Access Compliance Report

Public Rights-of-Way

(Curb Ramps)

Intersection ID: 46695	Main Street: GOLDFIELDS_DR	Cross Street: TROTTERS_RIDGE_RD	Location: SW
ADA ID: 807E2EFA8628	Ramp Type: PerpDiag	Initial Pass/Fail: Fail	Overall Compliance: No
Severity Score: 22.5			
Codes/Mitigation Info/Possible Solution		Field Measurements/Component Compliance

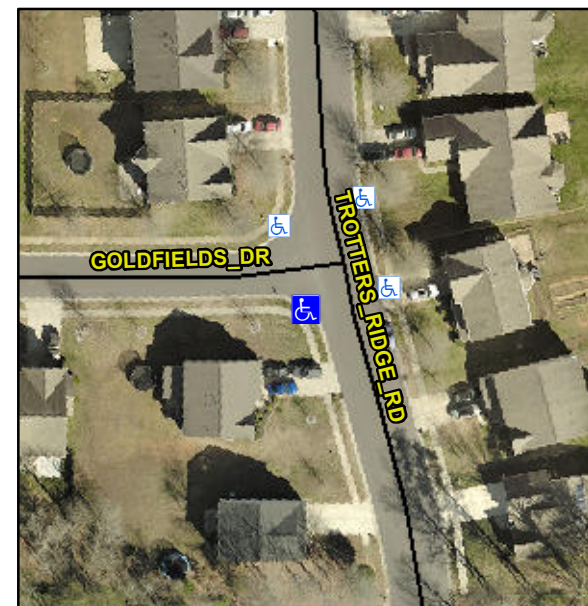
R304.5.1, R304.2.2, R304.5.3

Compliance	Description	Data	Compliance	Description	Data
N/A	Ramp Length (in)	47.0	No	Ramp Slope (%)	9.9
No	Ramp Width (in)	46.0	No	Ramp XSlope (%)	3.1
N/A	Flare Type LT	N/A	N/A	Flare Type RT	N/A
N/A	Flare Slope LT (%)	N/A	N/A	Flare Slope RT (%)	N/A
N/A	Flare Traversable LT?	N/A	N/A	Flare Traversable RT?	N/A
N/A	Landing Length (in)	N/A	N/A	DWS Provided?	N/A
N/A	Landing Width (in)	N/A	N/A	DWS Contrast?	N/A
N/A	Landing Slope (%)	N/A	N/A	DWS Length (in)	N/A
N/A	Landing X Slope (%)	N/A	N/A	DWS Full Width?	N/A
N/A	Landing Curb? (Y/N)	N/A	N/A	DWS Offset (in)	N/A
N/A	Shared Landing?	N/A			
N/A	Gutter Ponding?	N/A	N/A	Gutter Slope (%)	N/A
N/A	Gutter Lip Ht (in)	N/A	N/A	Gutter X Slope (%)	N/A
N/A	Painted X Walk1?	No	N/A	Painted X Walk2?	No
	X Walk 1 Direction	To E		X Walk 2 Direction	To N
N/A	X Walk 1 Width (in)	N/A	N/A	X Walk 2 Width (in)	N/A
	X Walk 1 Slope (%)	2.2		X Walk 2 Slope (%)	6.7
	X Walk 1 X Slope (%)	5.1		X Walk 2 X Slope (%)	0.0

Remove & Replace Curb Ramp With Two New Directional Ramps or Equivalent.
